R-12 NATURE OF REVISION

CARBON HILL MINE
ASMC P-3919, R-12

PERMIT MAP

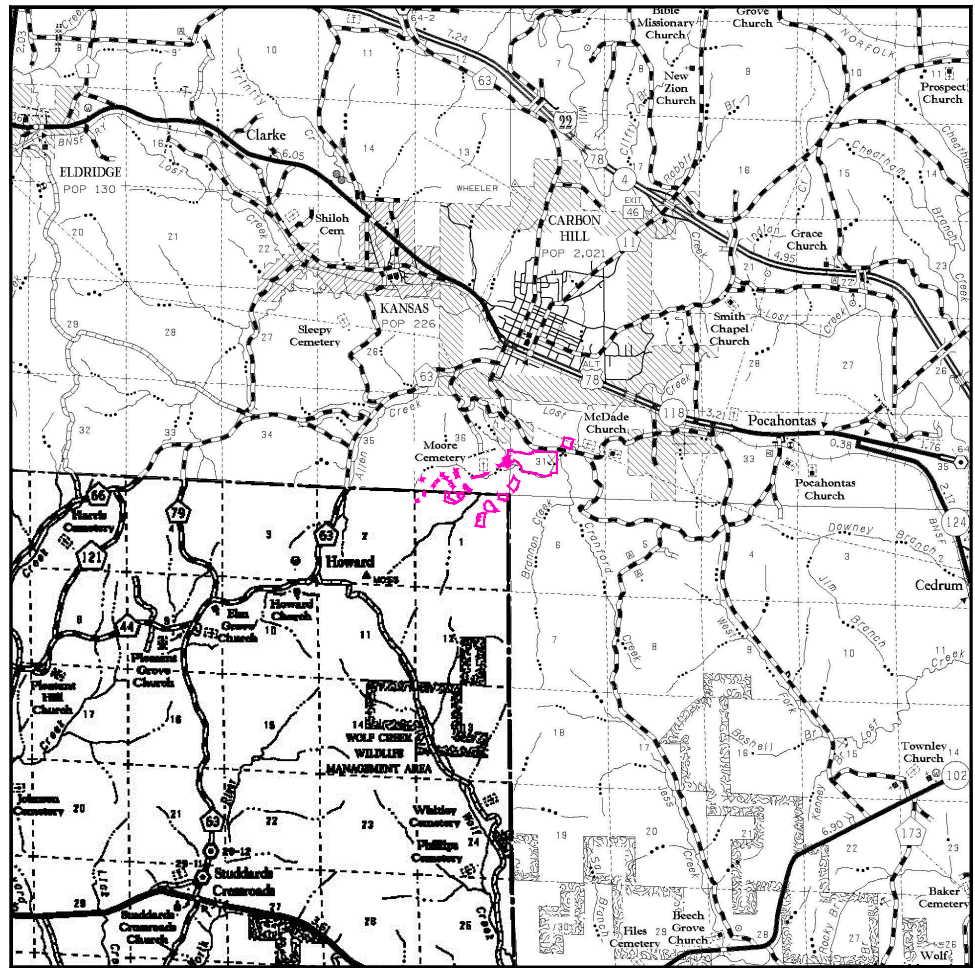
- DELETE SLURRY IMPOUNDMENT NO. 1, NO. 4, AND ACCESS (4 ACRES) FROM INCREMENT NO. 1 AS UNDISTURBED.
- DELETE SEDIMENT BASIN 011, 012, AND ACCESS (3 ACRES) FROM INCREMENT NO. 1 AS UNDISTURBED.
- DELETE 11 INCIDENTAL ACRES (BORROW AREAS) FROM INCREMENT NO. 1 AS UNDISTURBED.
- DELETE 2 INCIDENTAL ACRES (INJECTION WELLS AND ACCESS) FROM INCREMENT NO. 1 AS UNDISTURBED.
- MODIFY THE GENERAL PLAN.
- REQUEST AN EXEMPTION OF RULE 880-X-10D-.36(3)(e) TO REDUCE THE AMOUNT OF COVER MATERIAL REQUIRED FROM 4 FEET TO 2 FEET FOR COARSE REFUSE DISPOSAL AREA NO. 1.
